# A-One Polar Ltd

Bhulta, Rupgonj, Narayangonj.  
(23.754782, 90545710)  
27th April 2014

# Observations

# Observations Knitting & Garments building Building 1

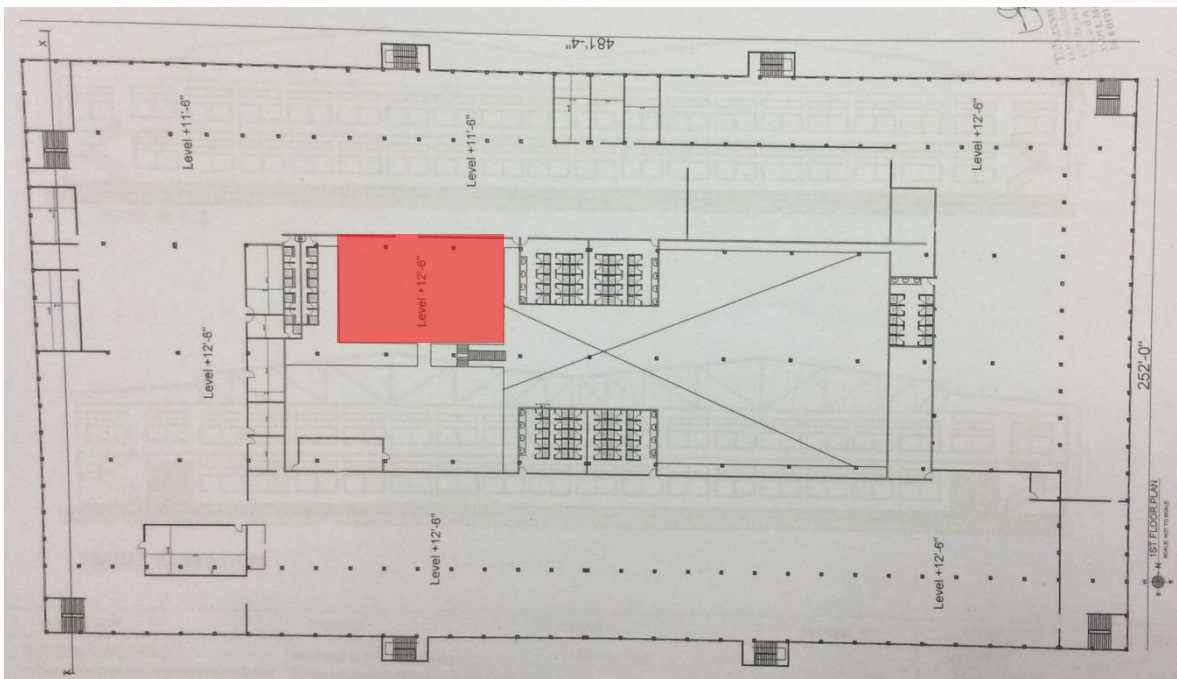
# Roof structure: no roof bracing

Stability: No roof bracing observed  
Structure relies on roof deck for  
transferring horizontal loads to  
façade walls.

# Heavy loadings on first floor

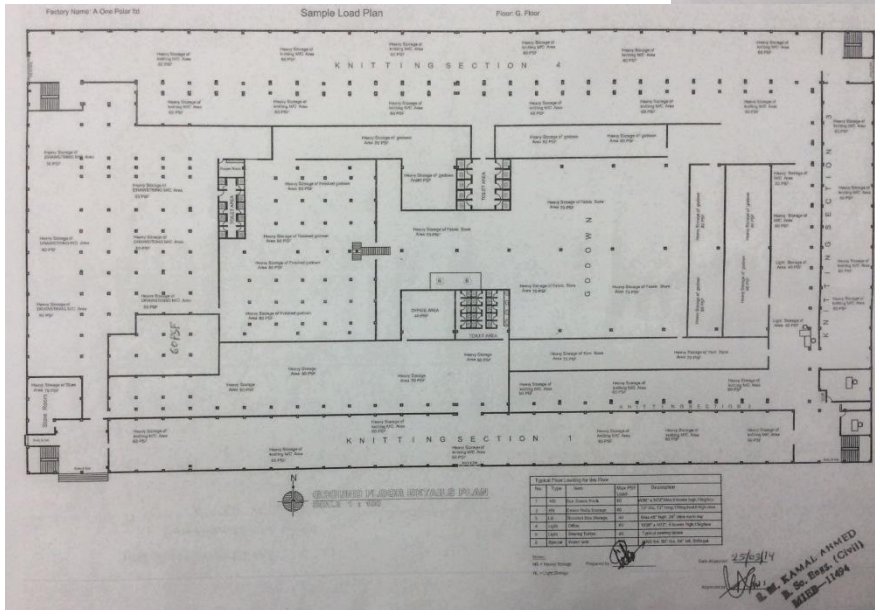
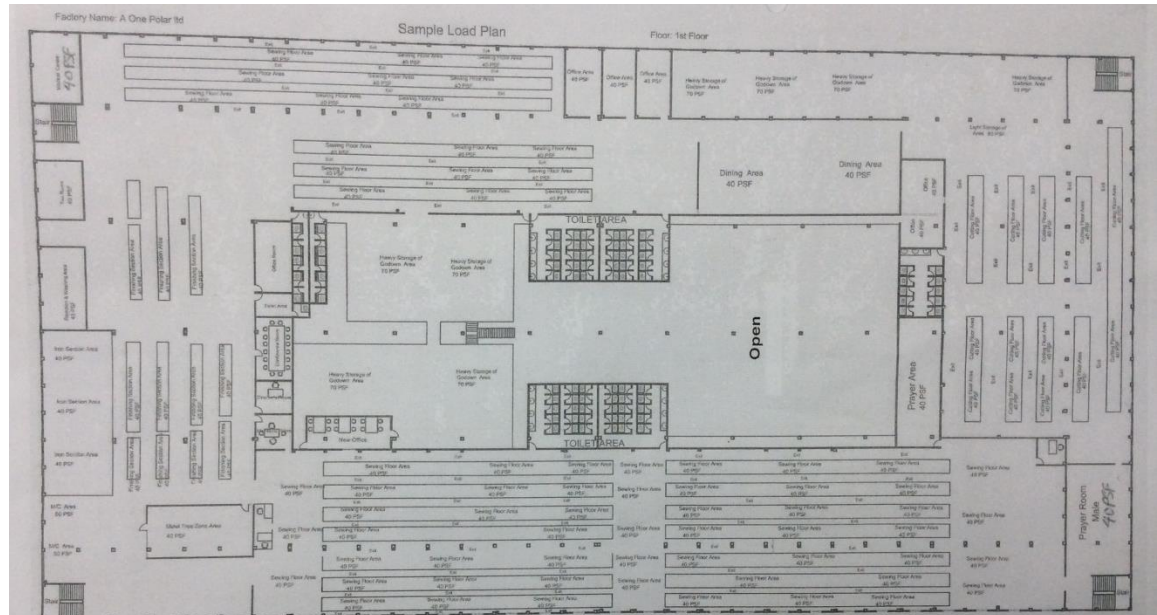
**Heavy loadings on 1<sup>st</sup> floor slab**

**Storage ± 3 kN/m<sup>2</sup>**

Loading plan provided dated 25-03-14

# Observed Aggregate

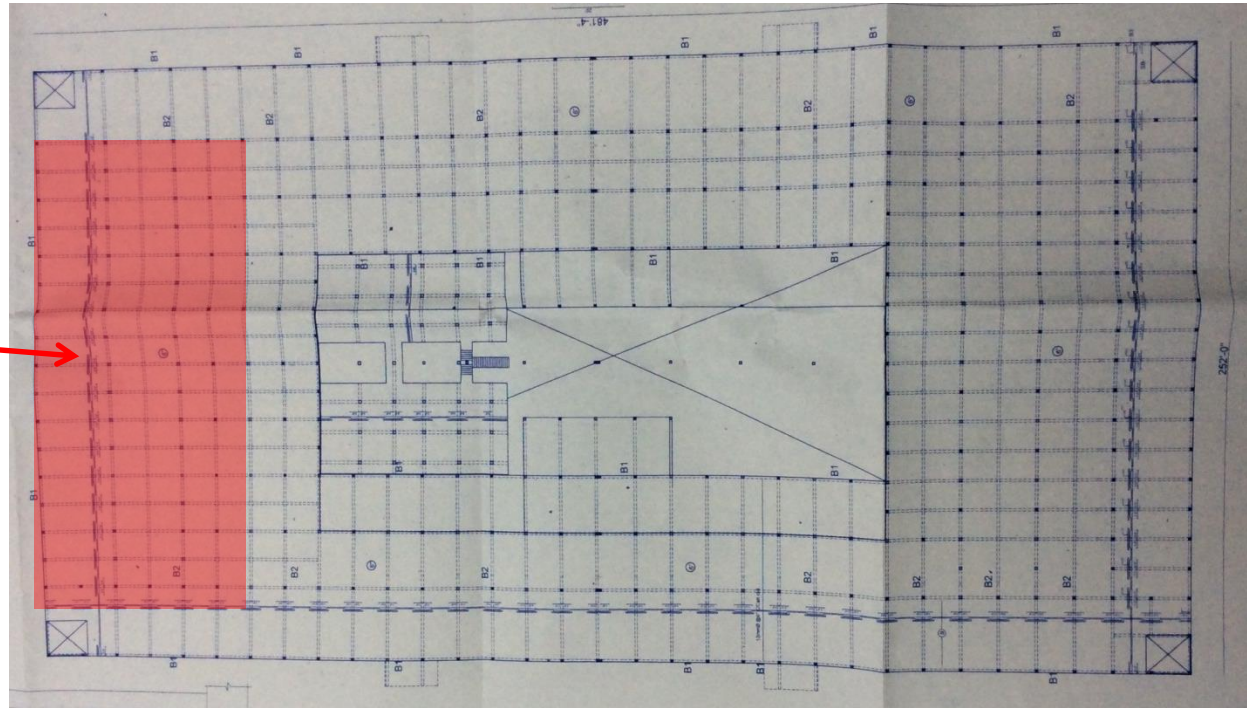
**Brick aggregate was observed in columns  
at ground floor and in slab 1<sup>st</sup> floor**

**Brick aggregate in slab 1<sup>st</sup> floor**

**Brick aggregate in column**

# Discrepancies between structural drawings and as-built situation

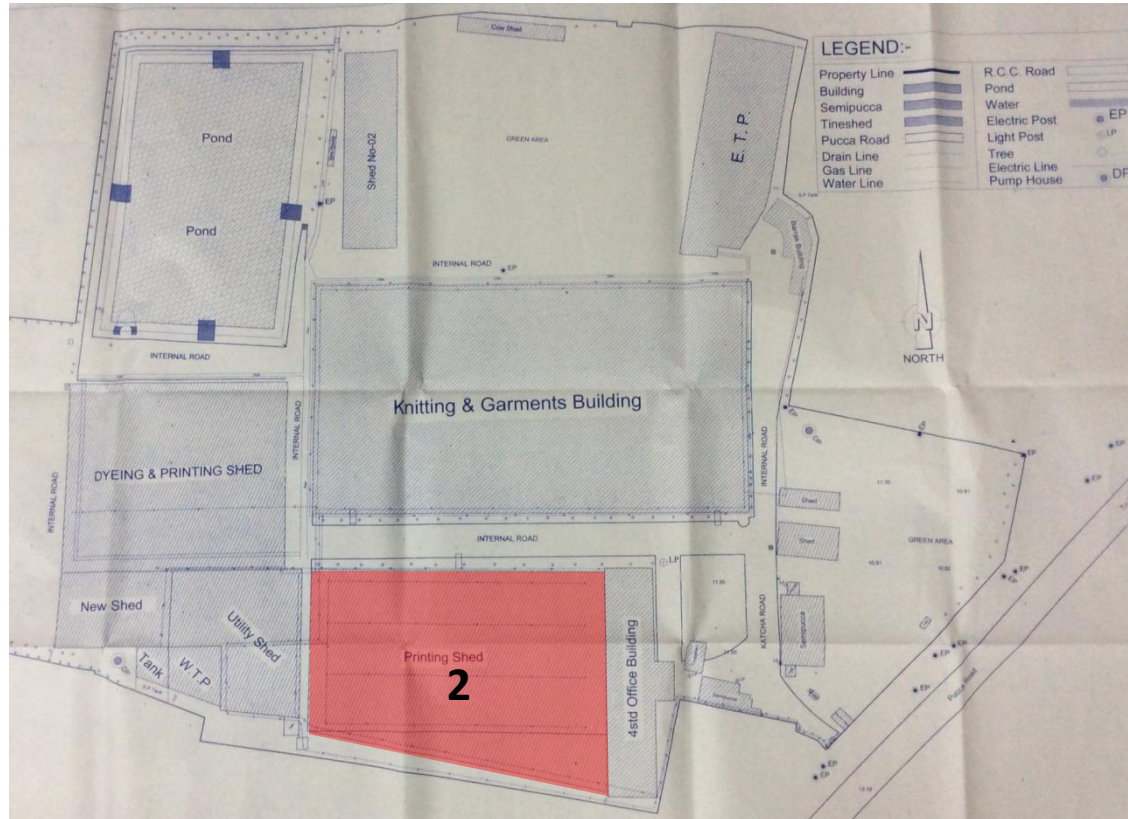
**Discrepancies between structural drawings and as-built situation:**

- Flat slab used instead of beam and slab used in two bays
- Grid and column location on ground floor do not match drawings

Item No.	Observation	Recommended Action Plan	Recommended Timeline
1	Differences between the as constructed and the structural drawings	Building engineer to check, collect information and produce accurate and complete as-built documentation.	6-weeks
2	Differences between the as constructed and the structural drawings	Building Engineer to assess what impact these differences have on the structural integrity of the building.	6-weeks
3	The lack of bracing in the roofs of all the building with reliance on the roof sheeting	Building engineer to review lateral stability of steel roof structure.	6-weeks
4	The lack of bracing in the roofs of all the building with reliance on the roof sheeting	Building engineer to design any additional structure deemed necessary.	6-weeks
5	The lack of drawings for the Water treatment building under construction	Engineer to analysis and design using verified material strengths and as built structural arrangement (E.g. reinforcement grade, concrete compression capacity for the structure prior to any loading of the building	6-weeks

# Observations Printing Shed Building 2

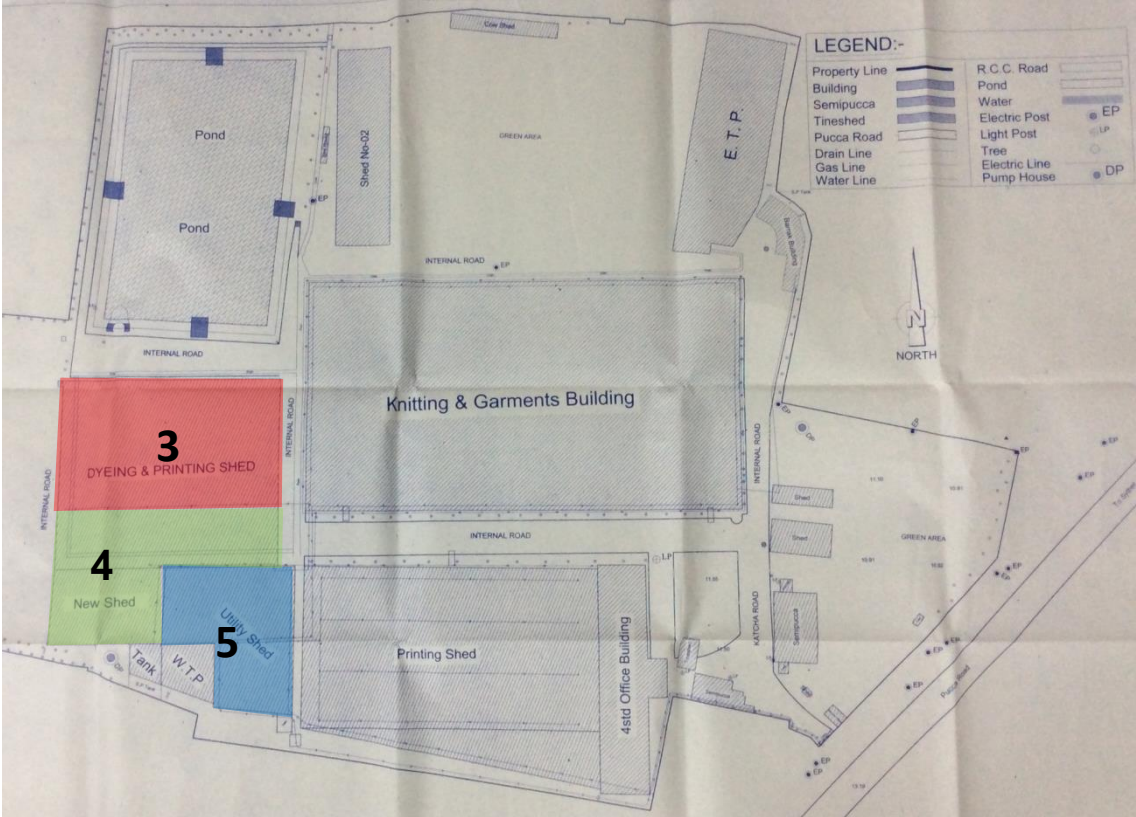
# Roof structure: no roof bracing

**Stability: No roof bracing observed  
Structure relies on roof deck for  
transferring horizontal loads to  
façade walls.**

# Observations Dyeing & Printing Shed, New Shed and Utility Building Buildings 3, 4 and 5

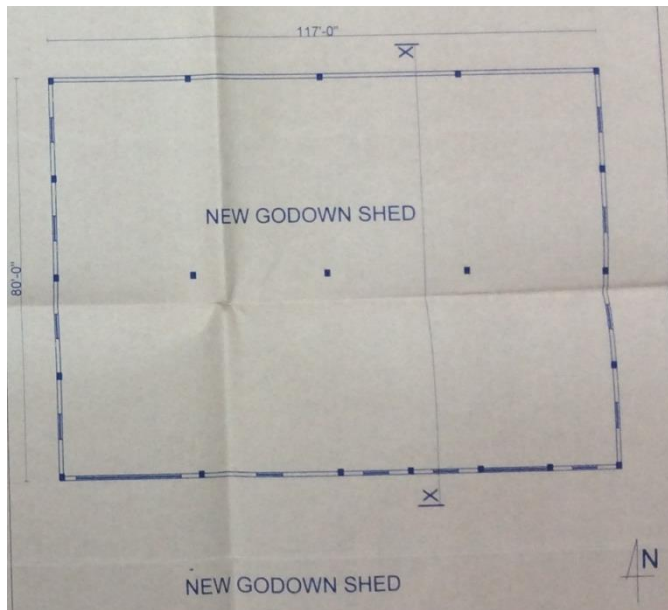
# Roof structure: no roof bracing

Stability: No roof bracing observed  
Structure relies on roof deck for  
transferring horizontal loads to  
façade walls.

# Structural drawings do not match as built situation

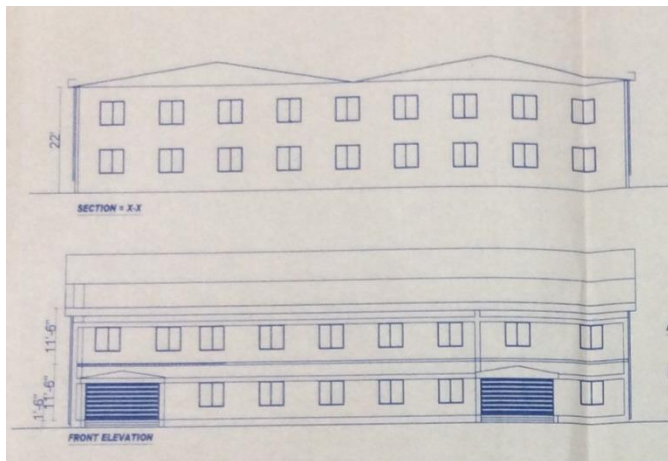
## Discrepancies between structural drawings and as-built situation of New Shed:

- Size and layout building do not match the drawings

# Observations WTP Building Building 6

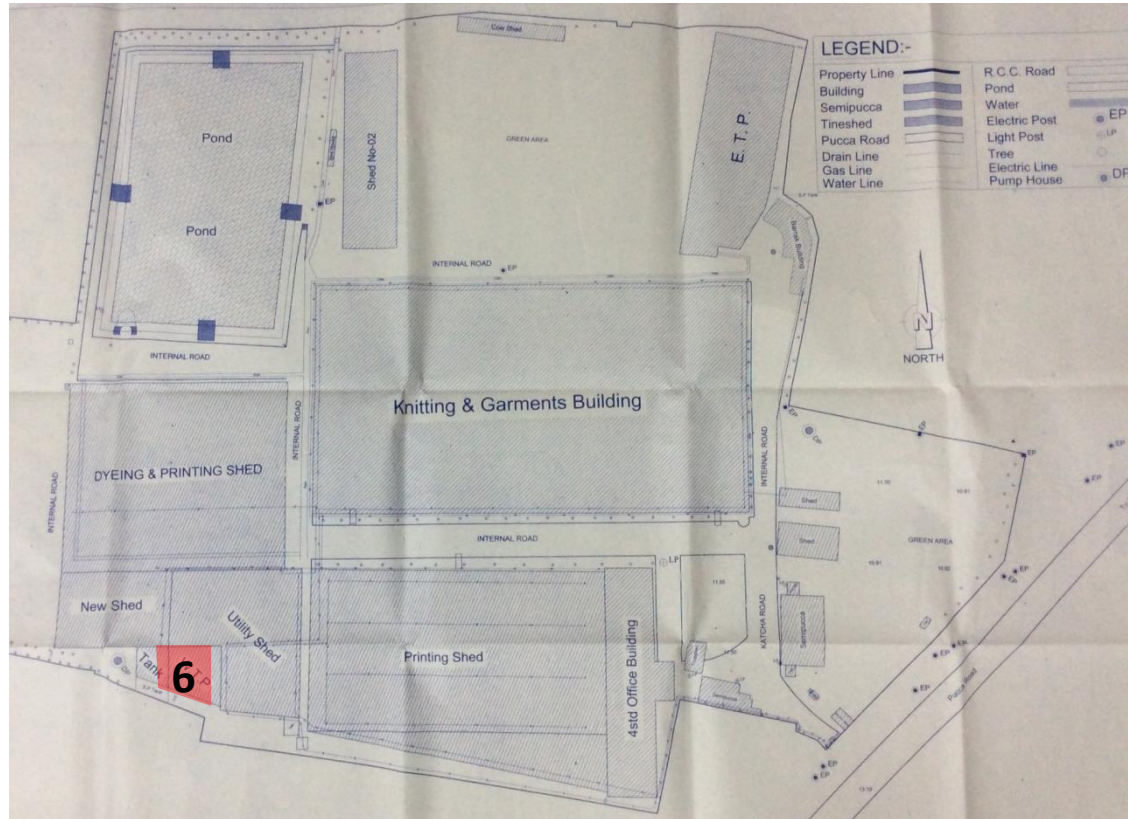
We were informed that as-constructed columns were made larger (collar of concrete cast around original columns) with addition corbels to facilitate higher floor loading. This was to enhance the capacity of the original cast beams and columns.

No permit drawing

6	The lack of drawings for the Water treatment building under construction	Loading of current constructed floor plates not to exceed the above analysis and justified design.	6-months

# Observations Canteen Building 7

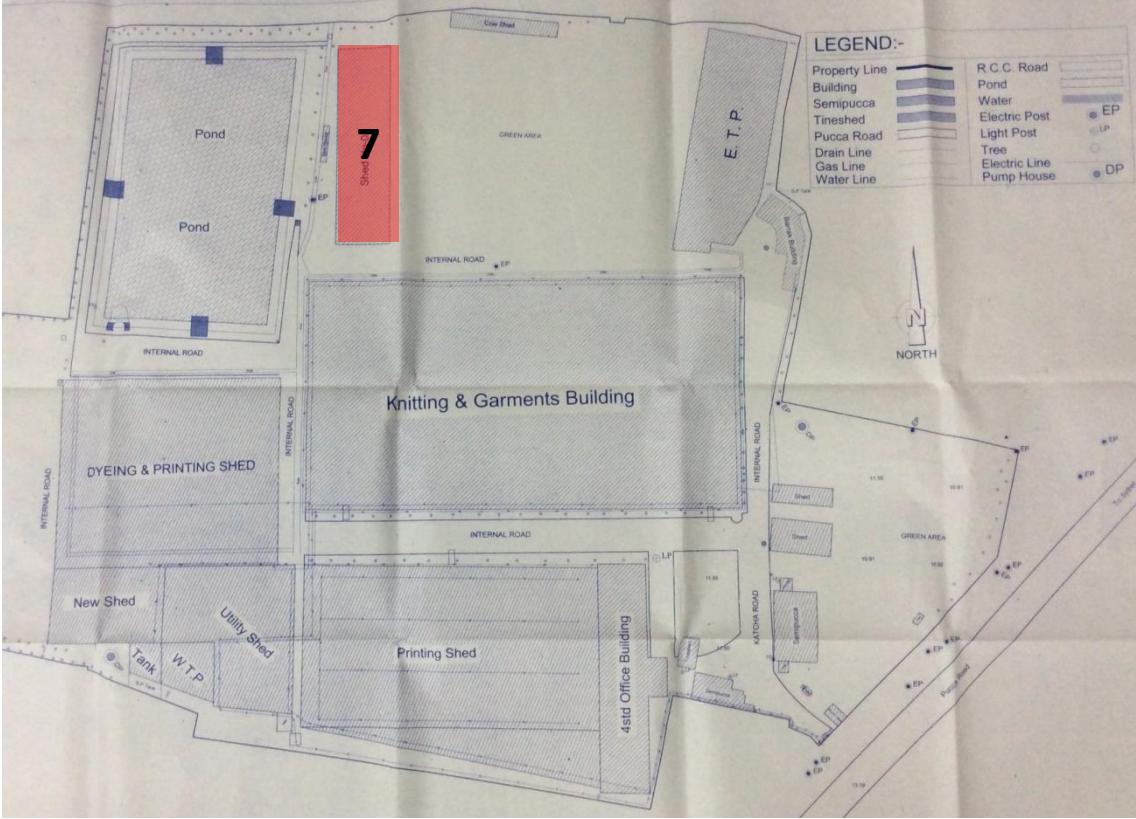
# Roof structure: no roof bracing

**Stability: No roof bracing observed  
Structure relies on roof deck for  
transferring horizontal loads to  
façade walls.**

**No permit drawing**
